SIB 65 06 20

## RECALL CAMPAIGNS 19V-852 AND 19V-853: DRIVER'S FRONT AIR BAG (NADI) INFLATOR

This Service Information Bulletin (Revision 7) replaces SI B65 06 20 **dated April 2021**.

### ► Preparing the new gas generator

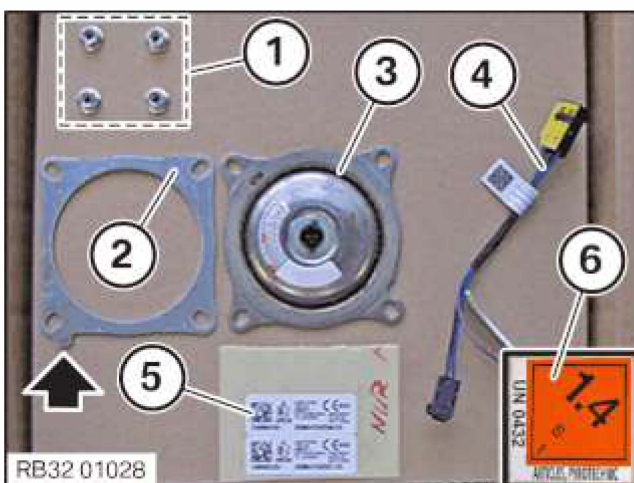
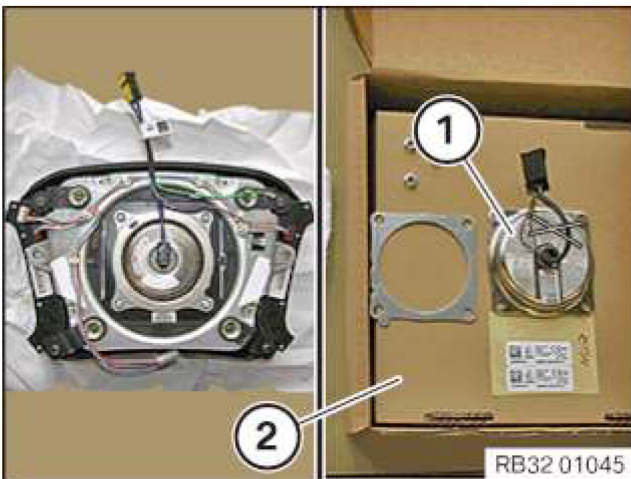
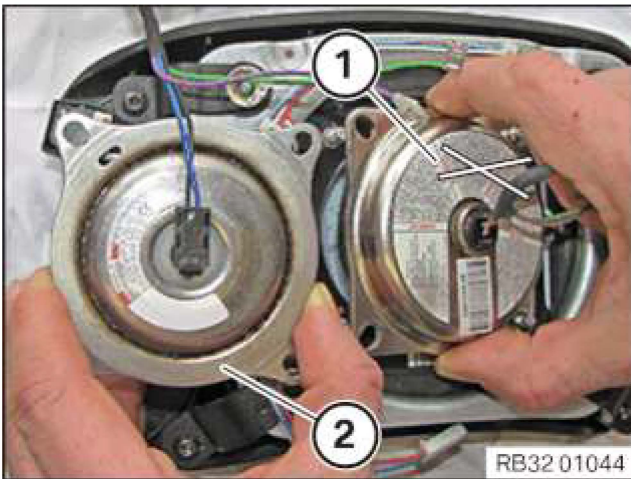
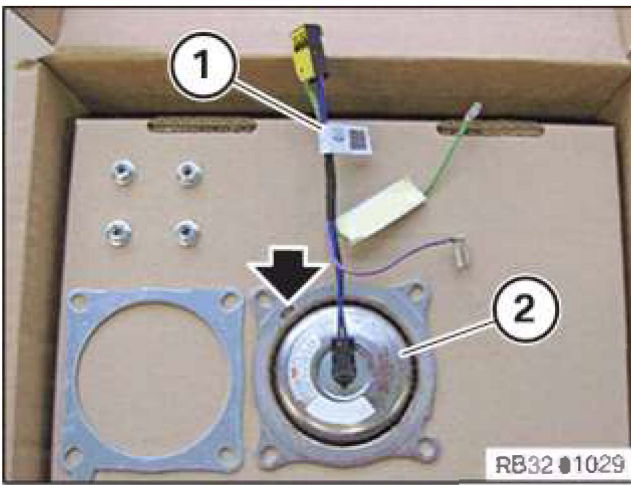
- Procedure/Parts/Warranty - Process change for the Dual Stage gas generator

- Unpack the new nuts (1), reinforcement plate (2), new gas generator (3), cable (4) and sticker (5) and place it as shown.
- Make sure that the groove (arrow) of the reinforcement plate (2) is positioned correctly.
- USA only:  
Dispose of the hazard sticker (6).

- Position the reinforcement plate (1) over the new gas generator (2).
- Make sure that the groove (arrow) of the reinforcement plate (1) is positioned correctly.

The groove (arrow) points downwards to the left.
